MEMORANDUM

TO: THE RHODE ISLAND PUBLIC UTILITIES COMMISSION
FROM: RICHARD HAHN AND AL PEREIRA, LA CAPRA ASSOCIATES INC., ON BEHALF OF THE
DIVISION OF PUBLIC UTILITIES AND CARRIERS
SUBJECT: NATIONAL GRID’S REQUEST FOR APPROVAL OF A SOLICITATION FOR PROPOSALS
FOR CLEAN ENERGY PROJECTS PURSUANT TO R.I.G.L. § 39-31-1 ET SEQ – DOCKET
NO. 4570

Figure 1

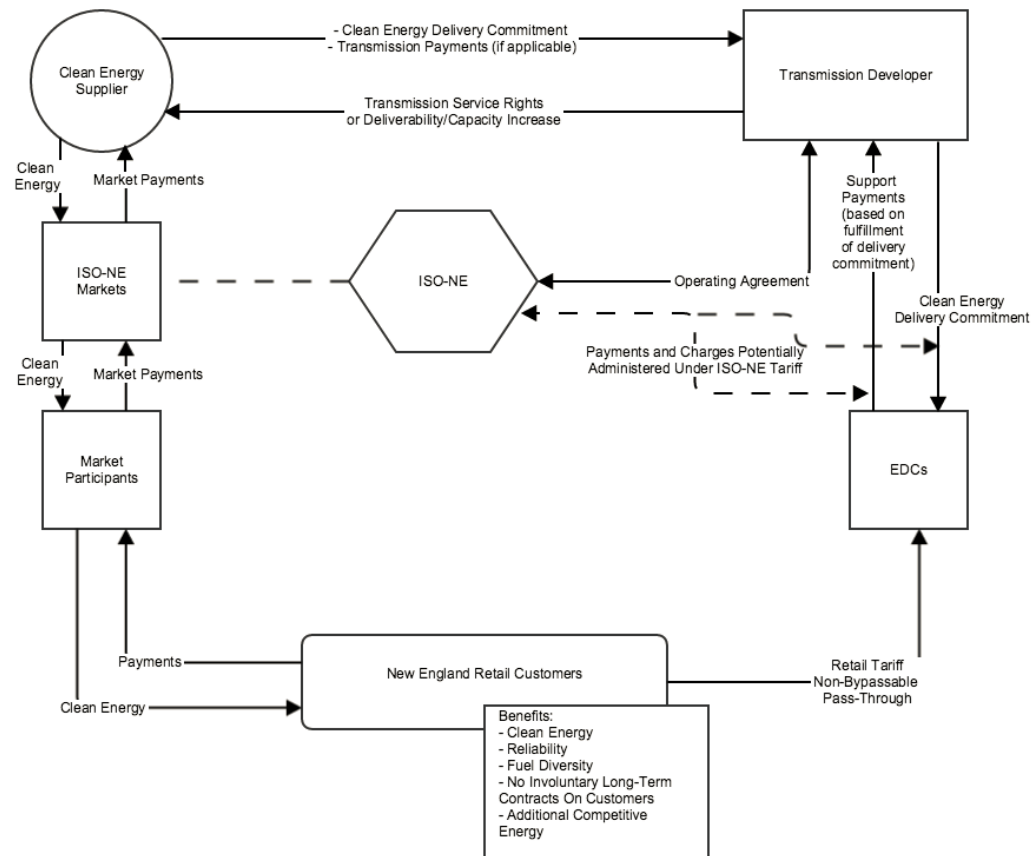
The DCM is dramatically different from a PPA. A PPA, with or without an associated transmission project, is a long-term contract between the supplier of Qualified Clean Energy and NECO which specifies, among other terms and conditions, the supply source to be used, the delivery point, the volume of energy to be delivered, and the price at which it is delivered. Once signed and approved, the PPA is a long-term commitment, which cannot be unilaterally terminated and can facilitate the financing and construction of new renewable energy resources. Previous contracts entered by or on behalf of NECO, such as Deep Water Wind or Bower Wind, were required before the supplier could secure financing. The DCM is based upon a FERC tariff, which is not a long-term contract. There is a robust history of using tariffs to facilitate the financing and construction of new transmission facilities. The most notable example of this is ISO-NE's Open Access Transmission Tariff ("OATT"), which has led to the installation of many billions of dollars' worth of new transmission. The payments made under the ISO-NE OATT are based upon cost of service revenues requirements with true-up mechanisms. However, we are unaware of new transmission projects in ISO-NE where the level of payment under the tariff is tied to and dependent upon the delivery of energy from a third party. It is uncertain how FERC will respond to such a proposed tariff. The DCM is a novel approach and it is possible that we might not know FERC's reaction until such a tariff is filed, which will be long after this RFP is completed and proposed projects

One concern with the DCM approach is that it may affect the pool of potential bidders. Existing "surplus" resources whose output is not currently committed or utilized and do not require financing may not need a PPA and can accept the DCM, while resources to be newly constructed and need a PPA for financing might not be able to accept the DCM. For example, if Hydro Quebec has an existing surplus of large-scale hydro power and wishes to export it to ISO-NE, Hydro Quebec may be willing to accept the DCM. In this example, Hydro Quebec would be the energy supplier, and either Hydro Quebec or some other entity could be the transmission developer.³ This might provide Hydro Quebec, or any other bidder with surplus energy, with an advantage over developers of new resources for which construction financing (and a PPA) is required.

A second concern with the DCM approach is that it will be difficult to evaluate such bids because the pricing for the Qualified Clean Energy will not be known to NECO or the Evaluation Team. Under the PPA approach, the price will be specified and can more easily be compared among

Based upon this discussion, we find that the DCM approach is generally in compliance with the Act, but the Company must provide further explanations of how such bids will be evaluated.
